# City and Borough of Sitka

## MEMORANDUM

**Subject:** Public Works Department recommendations on Alaska Department of Transportation plans for Sawmill Creek Road improvements

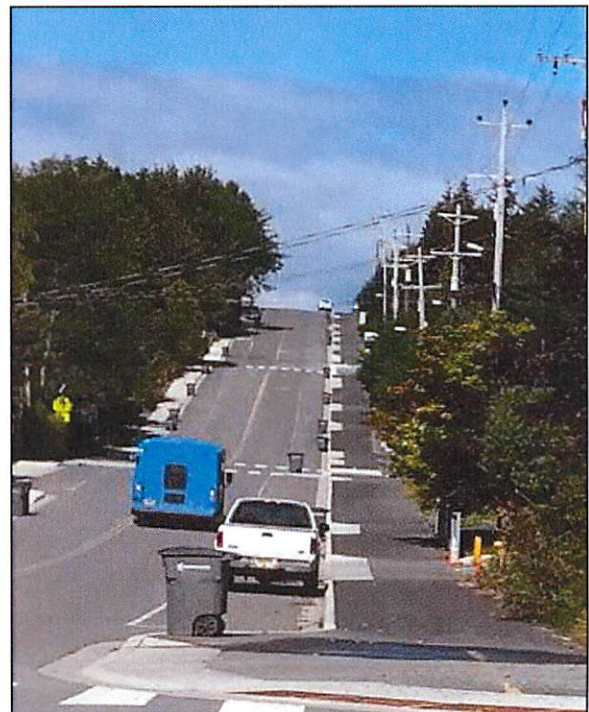
Option 1 would reconstruct this segment of SMC Road essentially as it is today: two 13.5-foot-wide driving lanes with on-street parking and 5-foot-wide sidewalks on either side of the road. Option 2 would establish two 5-foot-wide bike lanes between the curbs and provide a wider sidewalk on the water (south) side of the road by narrowing the driving lanes to 11 feet wide and by eliminating the parking lane on the water side of the road. Both options will comply with relevant design standards. However, Option 2 is more consistent with the alignment of the rest of SMC, extending from Jeff Davis to the Gary Paxton Industrial Park, in that it better accommodates cyclists and provides a wide

Public Works recommends the following features be included in the project:

2. Public Works would like to see driveway cuts similar to the Edgcumbe Drive multi-use path installed on this project if Option 2 is selected. These partial-width cuts would allow half of the pathway to maintain the same grade across the driveways, which would eliminate dips in the “wide sidewalk.”

3. The use of asphalt pavement for the Option 2 “wide sidewalk.” This would eliminate the control joints that have to be installed across a concrete sidewalk, and would also produce a smoother ride for wheelchairs, strollers, skateboards, etc., and would be consistent with the pedestrian pathway paralleling the rest of SMC.
